STAFF RECOMMENDATION
2415 Oakland Avenue
May 19, 2021

Application: New Construction—Infill; Setback Determination
District: Belmont-Hillsboro Neighborhood Conservation Zoning Overlay
Council District: 18
Base Zoning: R8
Map and Parcel Number: 10416020700
Applicant: Tyler LeMarinel, Allard Ward Architects
Project Lead: Melissa Baldock, melissa.baldock@nashville.gov

Figure 2. The front elevation showing the side bay that will encroach two feet (2') into the Beechwood Avenue side setback.

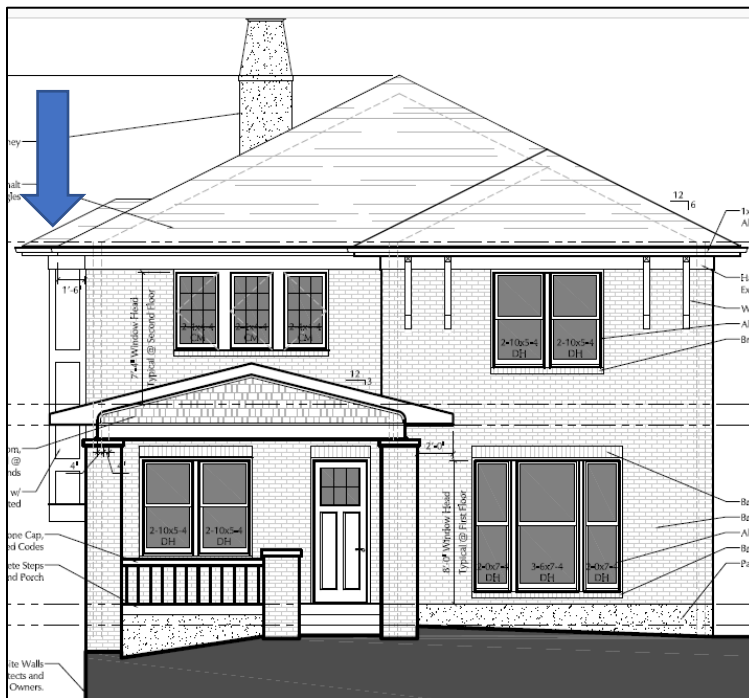
Also, along Beechwood the walls of the infill should be ten feet (10') from the side property line, but the applicant proposes a bay that is eight feet (8') from the side property line (Figure 2). Staff finds that the two-story bay's two-foot encroachment into the setback meets the historic context, as the other two-story houses on the corner appear to sit less than ten feet (10') from the side property lines. In addition, the bay is just approximately seven feet, six (7'6") wide, does not extend to the ground, and is overall modestly, scaled.

Drawings:
Site Layout Plan
Date:
04.30.2021

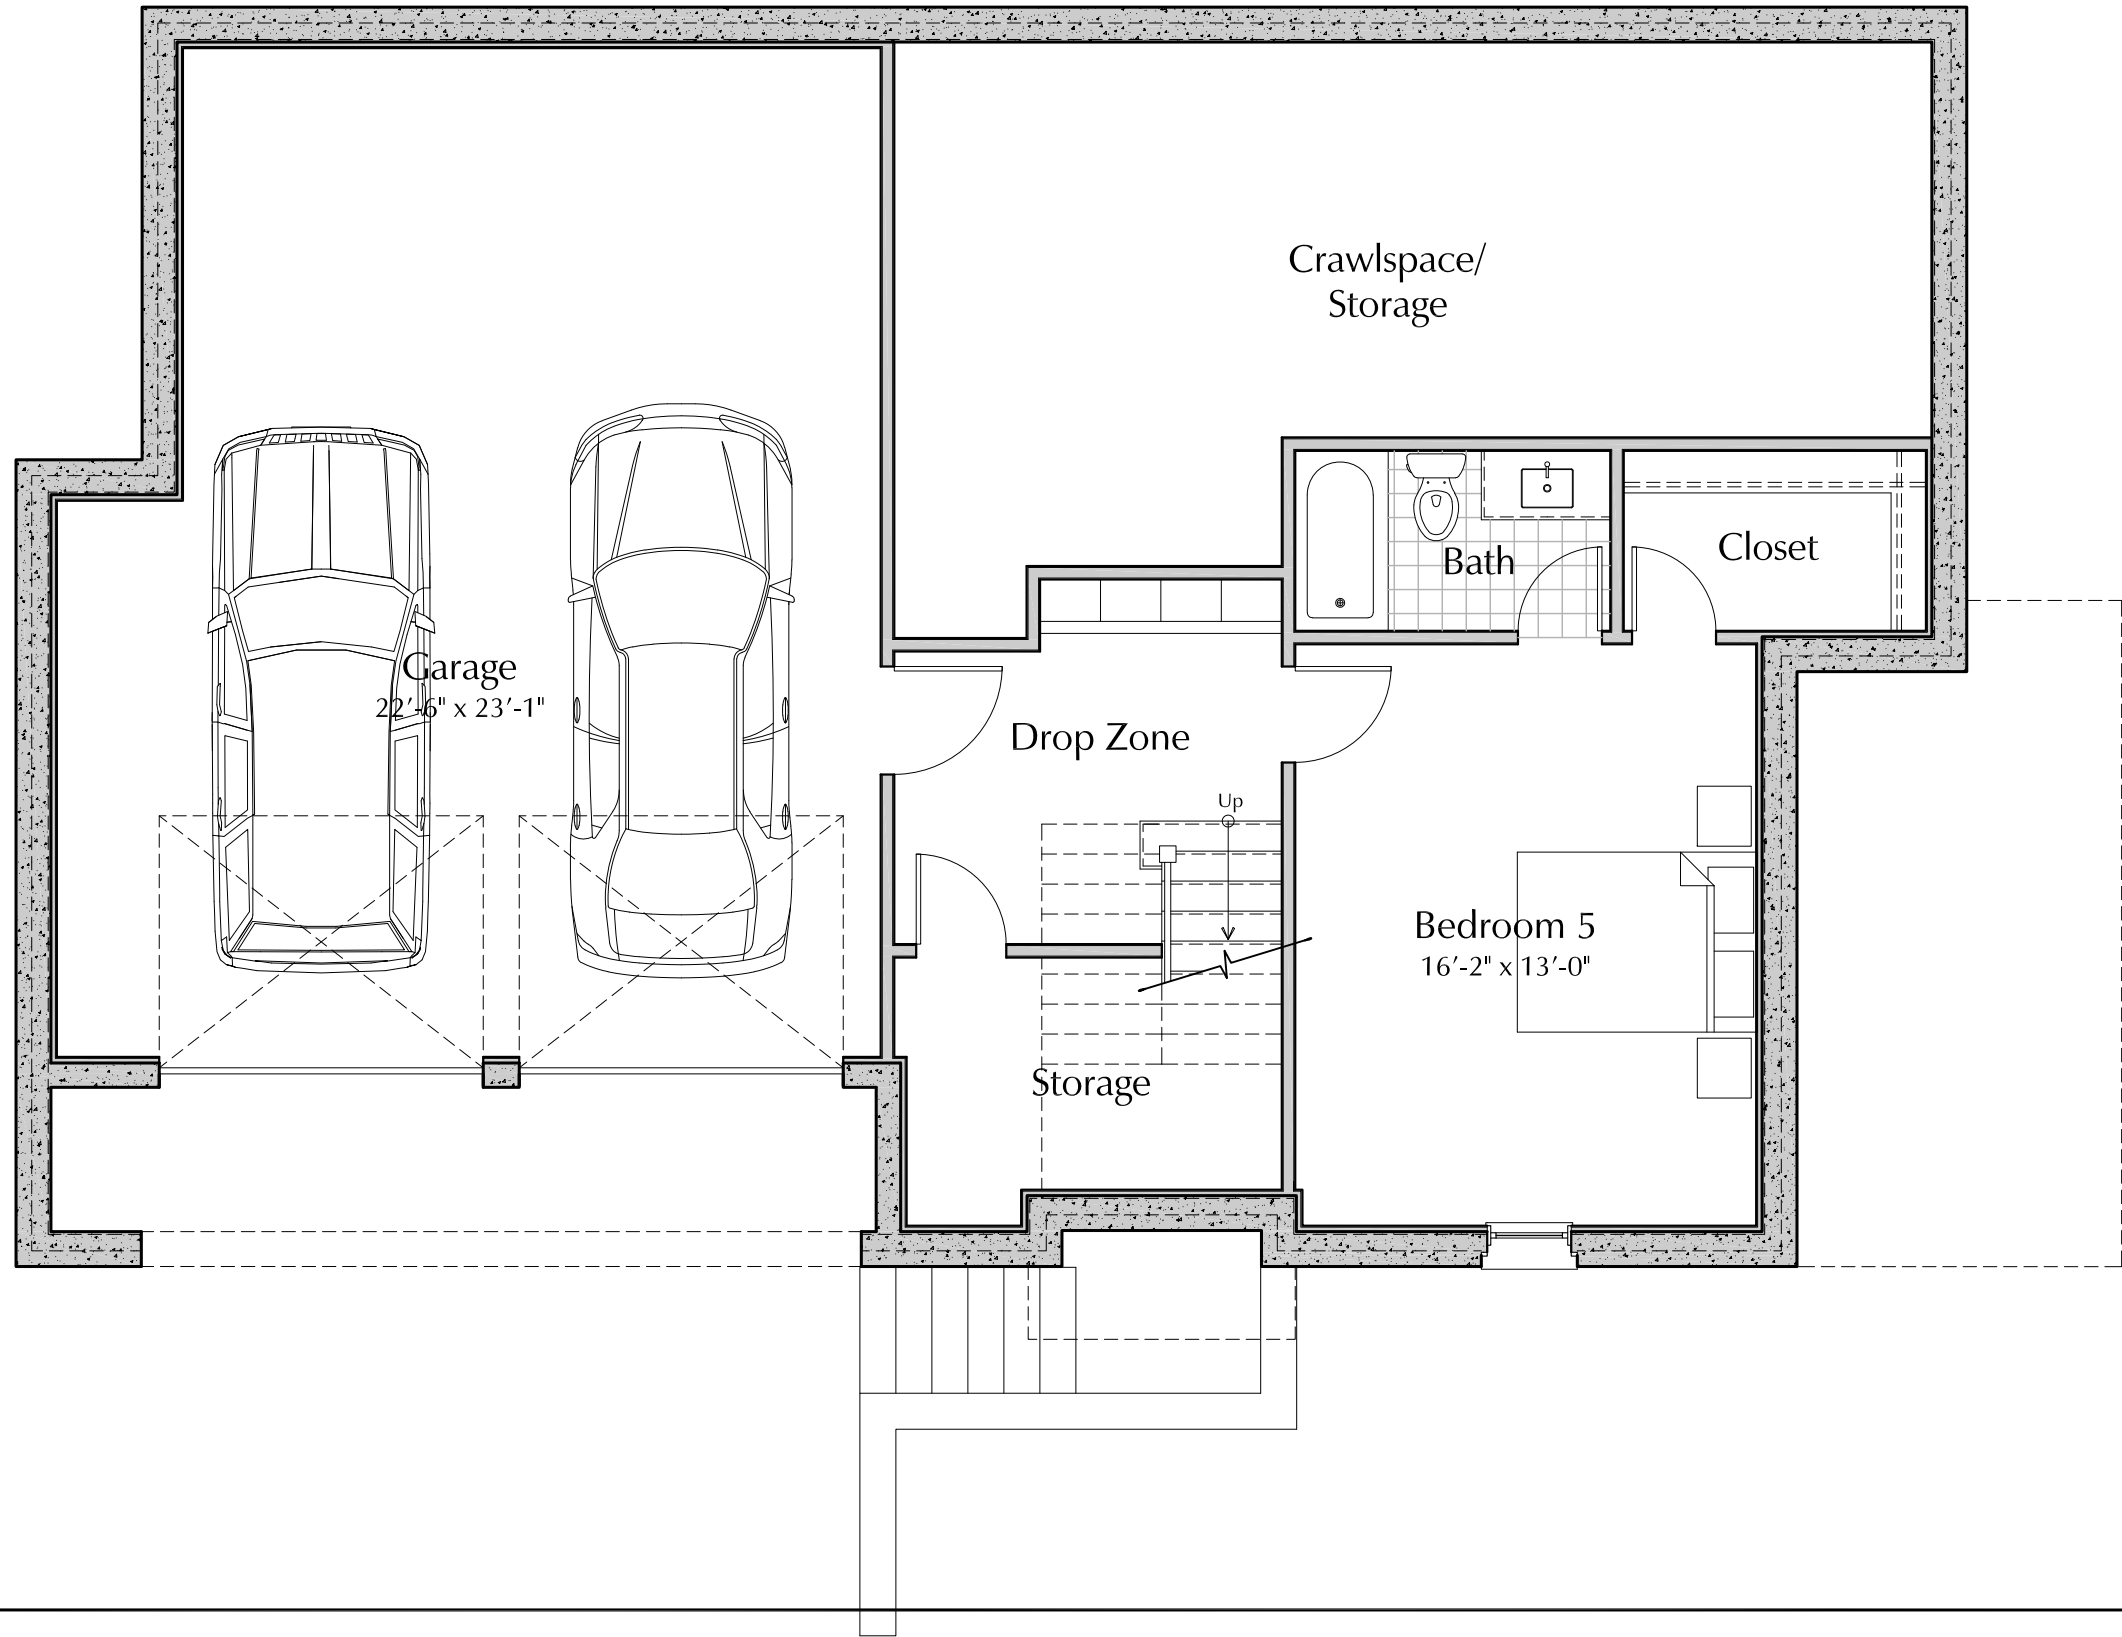
Setback & Rhythm of Spacing: The submitted site plan does not include the front setback of the historic house next door at 2413 Oakland Avenue. The applicant is aligning the front wall of the infill based on the existing front wall of the house that will be demolished. Since the walls of 2415 and 2413 Oakland have the same setback staff finds that this setback to meet the design guidelines and historic context. Staff will need to inspect the staking of the infill to ensure the appropriateness of the front setback. The front porch will extend beyond the front setback line by approximately four feet (4'), which staff finds to be appropriate because the porch is partial width and it will be open.

The infill meets the right side setback of five feet (5'), but requires setback determinations on the Beechwood Avenue and rear setbacks. Along Beechwood Avenue, garage doors are supposed to be 20' from the side property line, but the proposed infill will have garage doors that are fifteen feet (15') from the property line. Staff finds that the proposed setback of fifteen feet (15') for the garage doors will be sufficient to allow for vehicles to enter and exit safely from the garage without interrupting the sidewalk or street traffic.

Lastly, there is a required twenty foot (20') rear setback, but the applicant proposes a one-story porch that is just ten feet (10') from the rear property line. Staff finds that the encroachment of the one-story rear porch into the rear setback to be appropriate for several reasons. First, the lot is unusually shallow at just one hundred and fifteen feet (115'). Most neighboring lots have depths of one hundred and seventy-five feet (175'). In addition, the porch is just one story and is partial-width; it will have a width of approximately sixteen feet (16'). Lastly, the porch is pushed back from the Beechwood Avenue façade, where it will have less impact on the house behind it at 1700 Beechwood.

Staff finds the proposed setbacks and setback determinations to meet Section II.B.1.c. of the design guidelines.
